Kollaard Associates
Engineers

Re: Proposed Single Family Dwelling, Lot # 352 Ninaatik Place, Pathways, City of Ottawa, Kollaard Associates File # 230022

With regard to structural issues only, Kollaard Associates has reviewed the following drawings:

SK-1

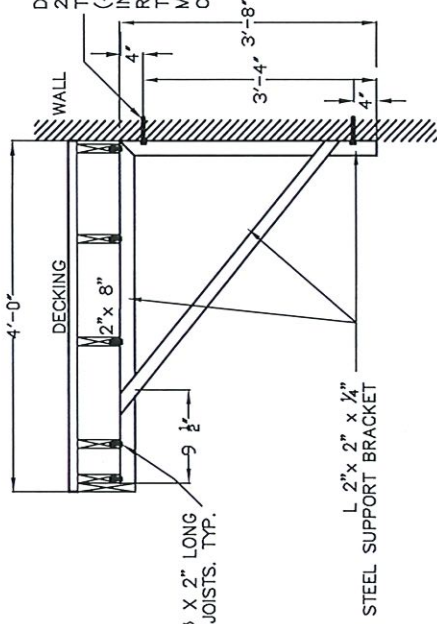
17. The proposed deck and steel bracket support are designed and approved by others (City Structural Design, Dwg. # SK-1, Dated December 2019).
